Drilling Holes for the 5880 Table Up Bracket

- Trendsetter VLF (5880)
- Trendsetter VLF AL (5880)

Fig.1: Table support section of frame (counterweight side), showing position of 2 new holes. [Reference: 57-1474D, sheet 19]

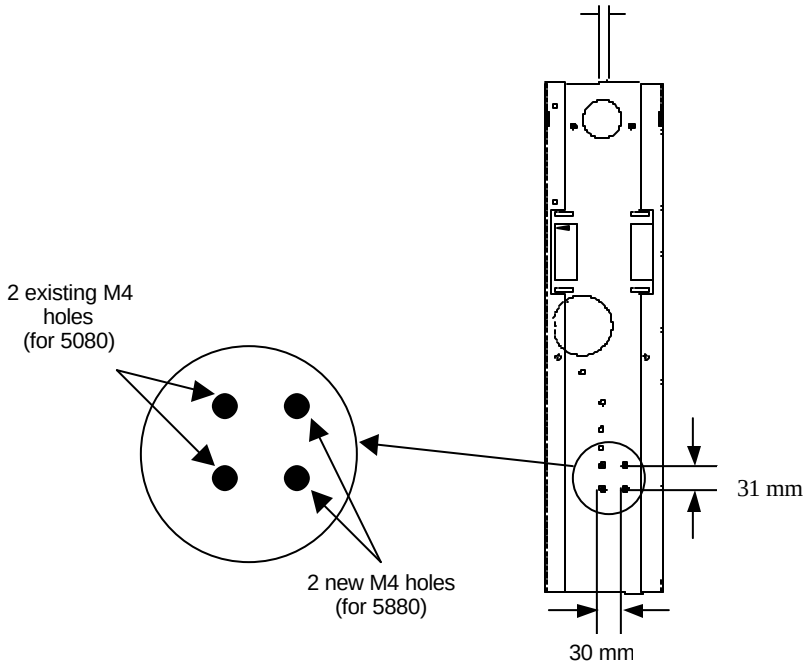
To prevent bending of the table up switch bracket (57-6492B) on 5880 machines, it must be installed 30mm to the right of the bracket position for 5080 machines.

Drill and tap two new 3.5mm holes beside the existing 5080 table up bracket holes, in the locations shown in Fig. 1 and Fig. 2.
